**PASSAIC COUNTY PLANNING BOARD
MINUTES OF A REGULAR MEETING
Thursday, February 21, 2019
930 RIVERVIEW DRIVE, SUITE 250, TOTOWA, NJ 07512**

SP-19-004 – NJDC Medical Office Building – 169 Minnisink Road, Totowa

SITE PLAN RENDERING

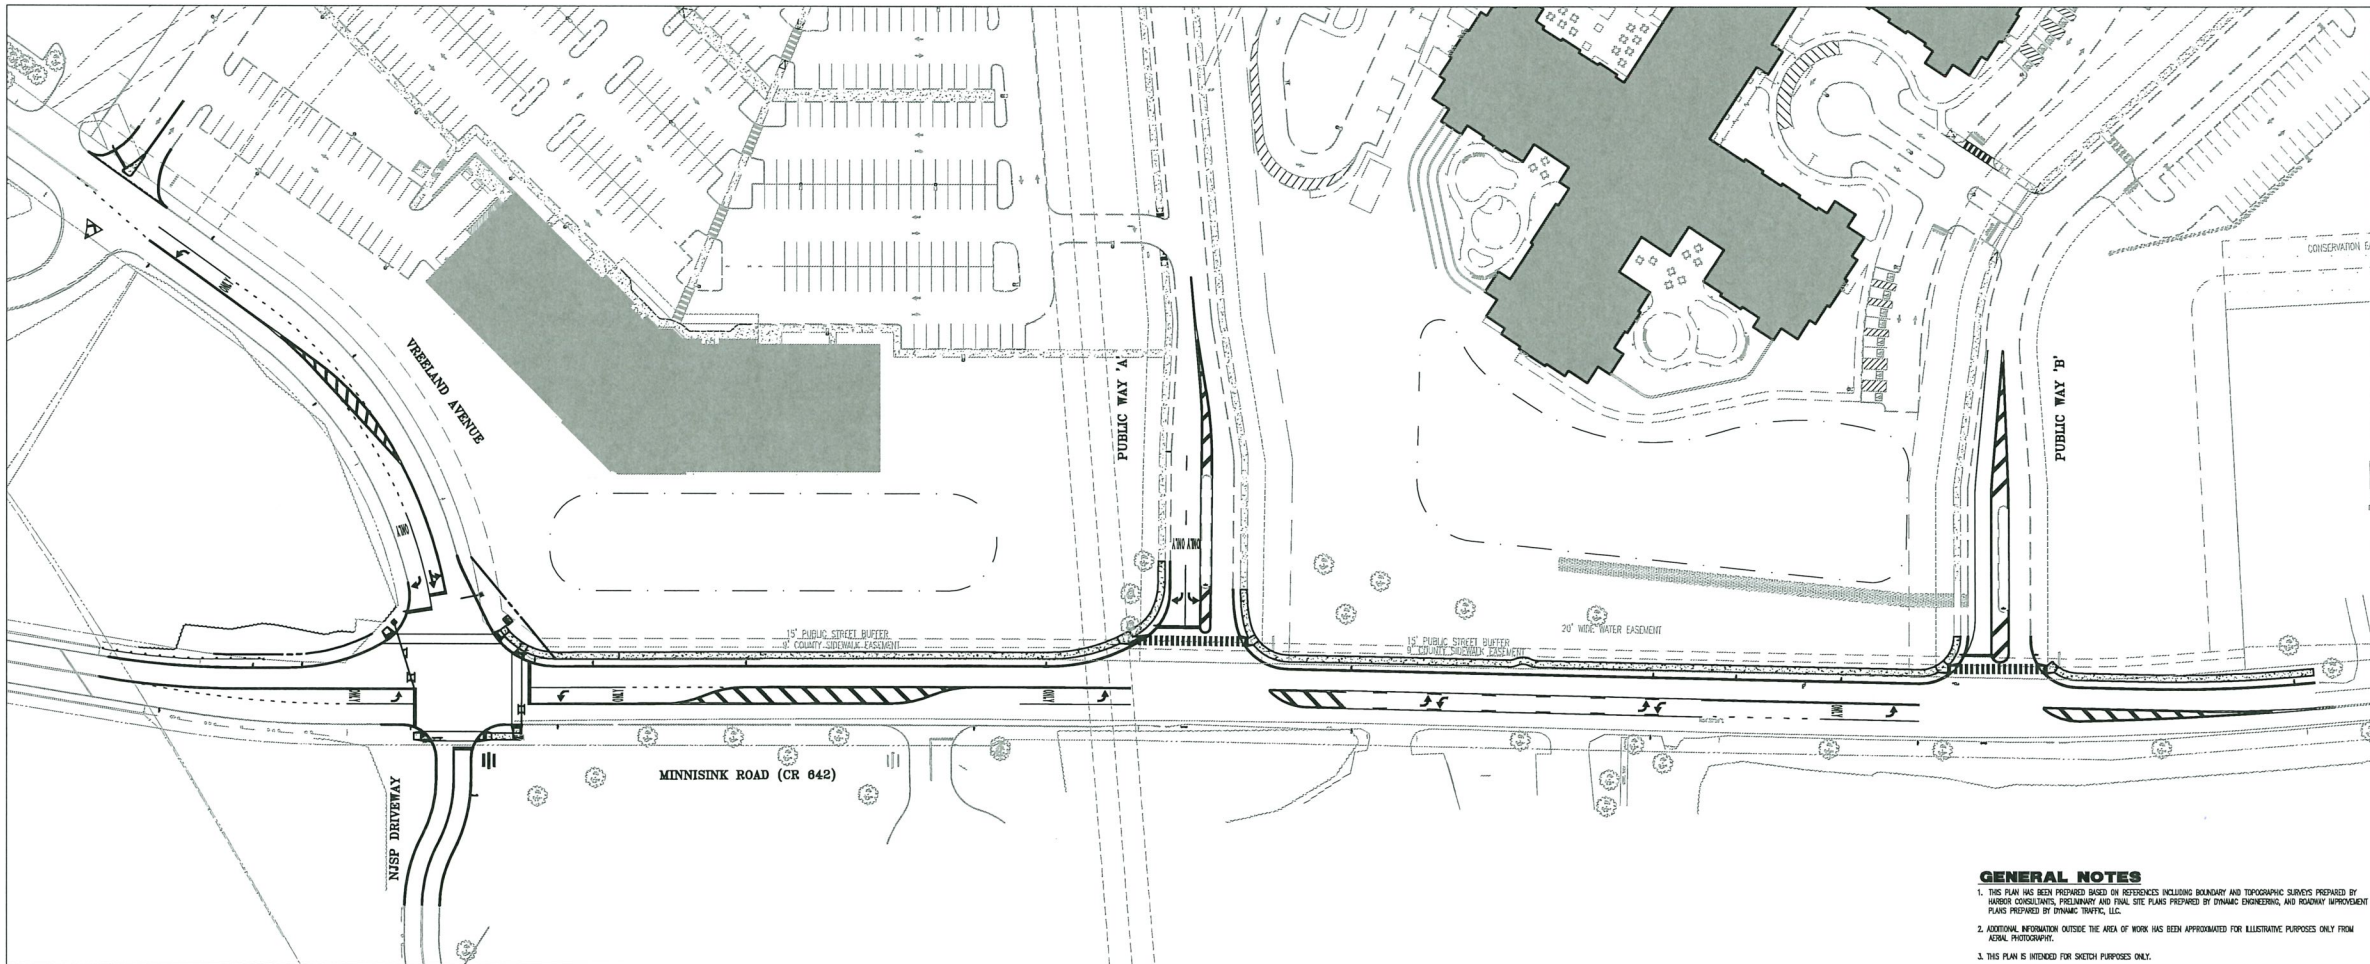
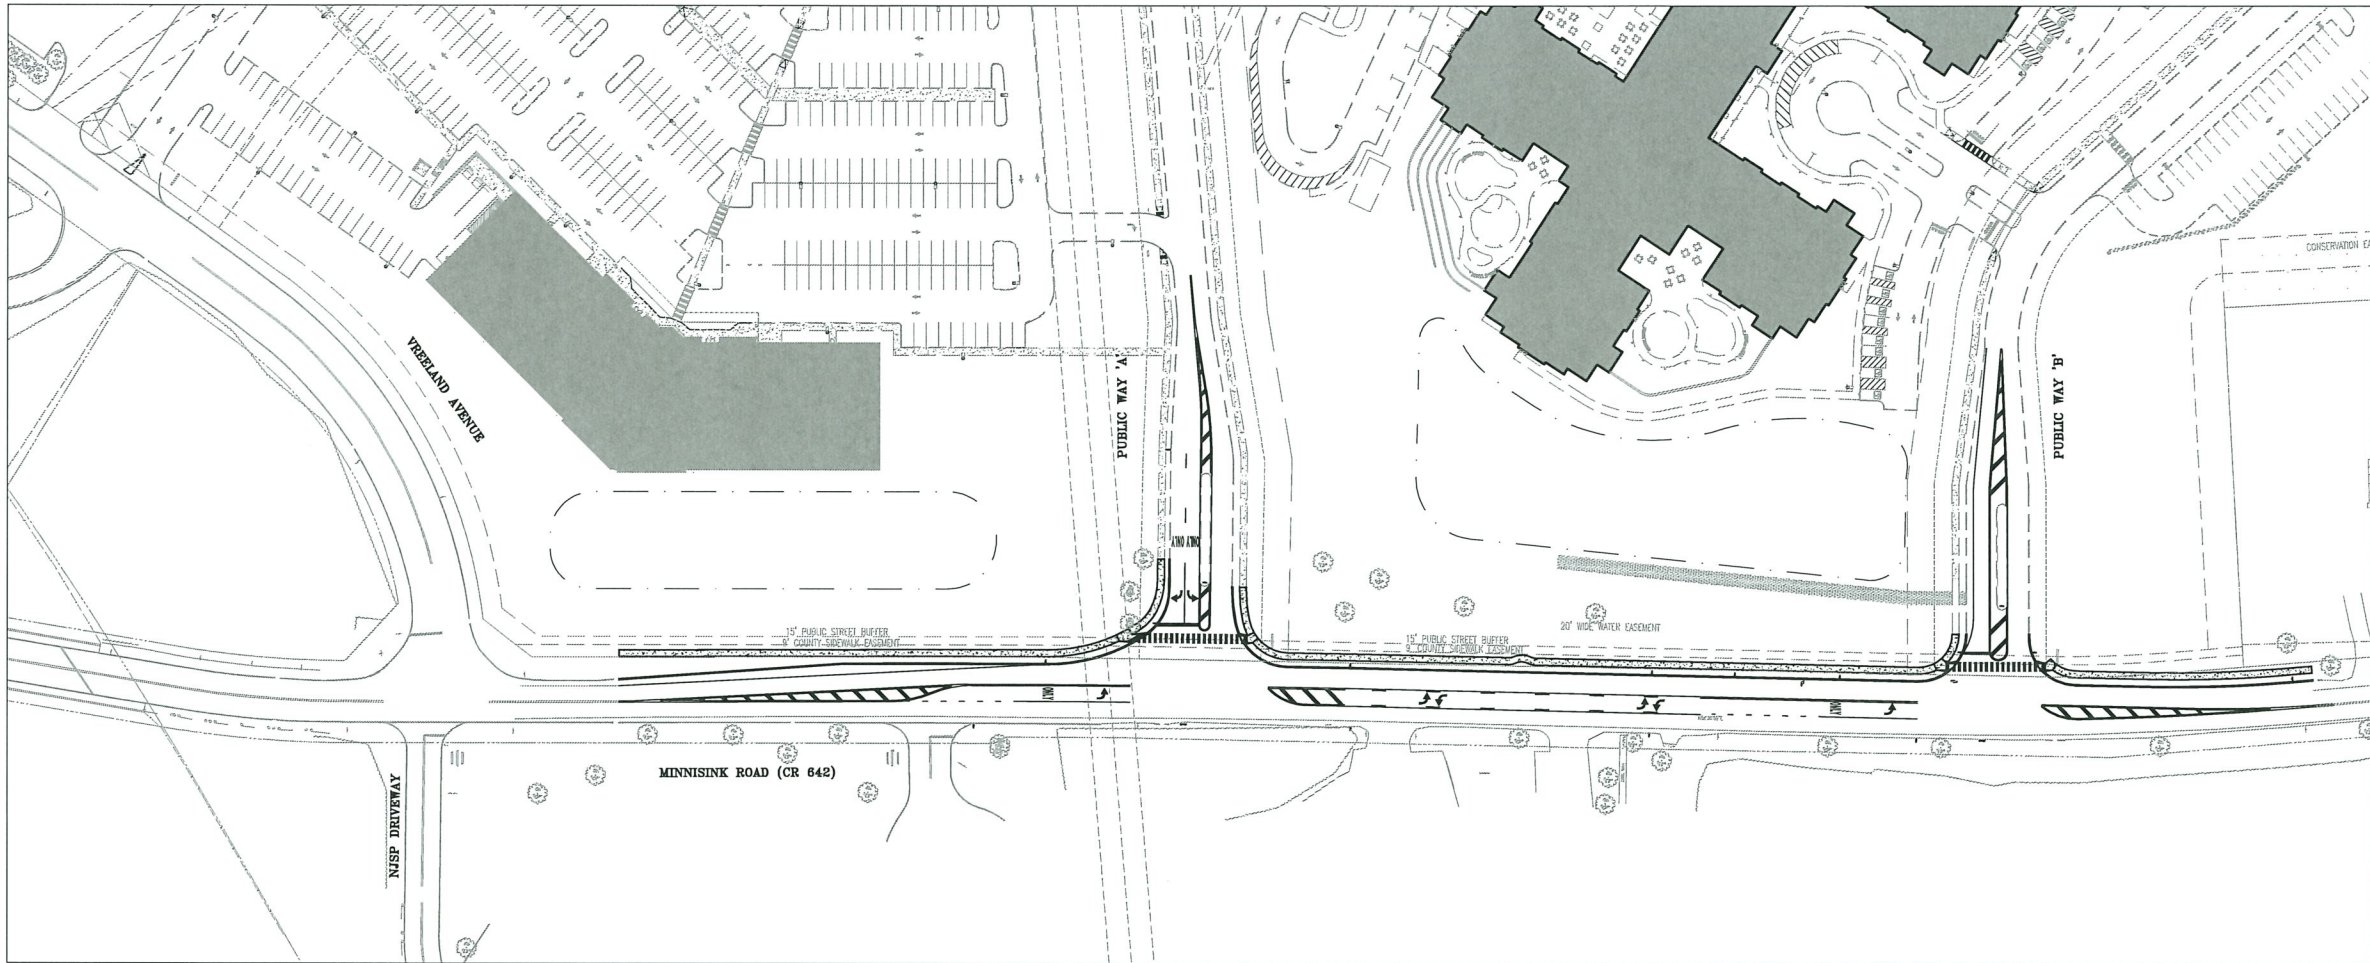
There are conditions that must be satisfied before the application can be granted unconditional approval. The roadway improvement plans must show a raised driveway apron, per County detail, across proposed Public Way B. The site plan and roadway improvement plans must both show ADA-compliant curb ramps and continental-style crosswalks (horizontal bars, no transverse lines) across proposed Public Way A. The proposed sidewalk along Minnisink Road must extend to the intersection with Vreeland Avenue. Curb ramps, per ADA standards, must be installed at the intersection. The proposed sidewalk along Minnisink Road must be extended across the entire property frontage of Lot 19.02, with raised driveway aprons provided at the existing site driveway. It must be clarified where

Chairman Simpson inquired about the shape of the end of Road A and if it is a roundabout. He also inquired as to the reason for the underestimation of the site's trip generation.

Commissioner Edmond also asked if Road A and Road B connect on site and if the proposed landscaping would be located behind the sidewalk or in front of the sidewalk (i.e. between the sidewalk and the street).

Chairman Simpson inquired if the lot line reflects the future road widening.

Commissioner Edmond suggested Planning staff reexamine a raised sidewalk at Road A, given the high number of parking and trips generated, because that sort of sidewalk would not be ideal for that level of traffic volume. County Engineer Pera clarified that the raised sidewalk is only proposed for Road B, not Road A.
